OFFICE OF NEW REACTORS

ASSESSMENT OF WHITE PAPER SUBMITTALS ON DEFENSE-IN-DEPTH, LICENSING BASIS EVENT SELECTION, AND SAFETY CLASSIFICATION OF STRUCTURES, SYSTEMS AND COMPONENTS

NEXT GENERATION NUCLEAR PLANT

PROJECT 0748

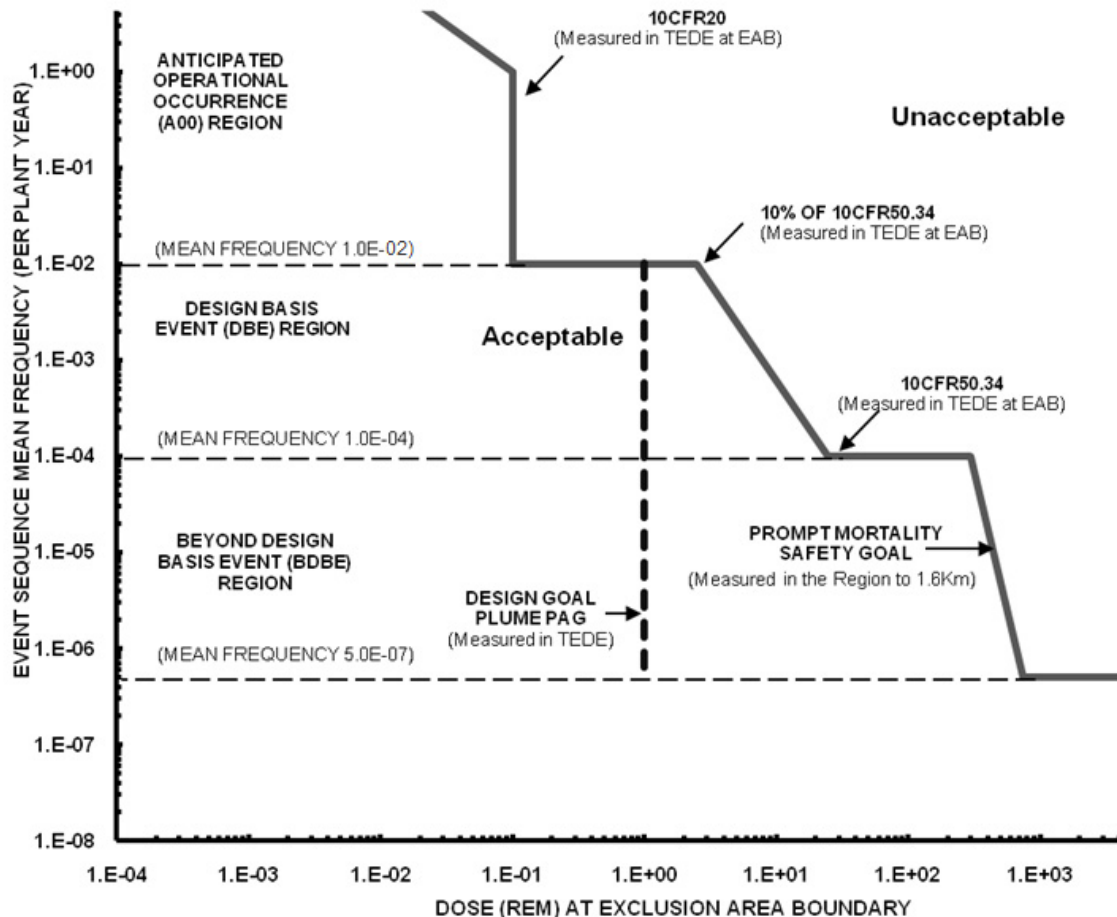
The NGNP Project proposes dose acceptance limits on the LBE consequences and the analysis basis for the LBE categories which are generally consistent with the NGNP LS with several significant exceptions. The proposed dose acceptance limits for the NGNP safety analyses are depicted by Figure 3 in the NGNP LBE Selection White Paper. Figure 3 is reproduced below.

The event frequency versus dose consequence acceptance line shown in this figure is generally referred to as an “F-C curve.” For events in the AOO frequency region, the proposed F-C curve has been constructed based on the dose limits in 10 CFR Part 20. For events in the DBE frequency region, the proposed F-C curve has been constructed based on the dose limits in 10 CFR 50.34.⁴ For events in the DBE region, the proposed F-C has been constructed such that a reduced dose would be allowed as DBE frequency increases. For the DBAs (which are selected and derived from the DBEs), it is proposed that dose criteria in 10 CFR 50.34 apply (i.e., without reduction). For events in the BDBE frequency region, the proposed F-C curve has been constructed based on the prompt mortality safety goal. It is proposed that the dose limits be associated with and apply at the NGNP exclusion area boundary (EAB).

The working group recognizes that there are a large number of ways to construct an F-C curve that utilizes the dose acceptance criteria of existing NRC regulations and applies them to inferred frequency ranges for the event categories to meet the above stated objectives. For example, the proposed frequency consequence curve shown in Figure 3-3 of NUREG-1860 was developed in connection with the NRC staff's feasibility study for a risk-informed and performance-based regulatory structure for future plant licensing. The F-C curve shown in Figure 3-3 of NUREG-1860 was developed using the same LWR regulations used to develop the F-C curve proposed by the NGNP project. The development of the F-C curve in NUREG-1860 also includes consideration of additional dose acceptance criteria associated with national and international radiological health standards.

The working group believes that the proposed F-C curve and associated dose calculation framework should be revised.
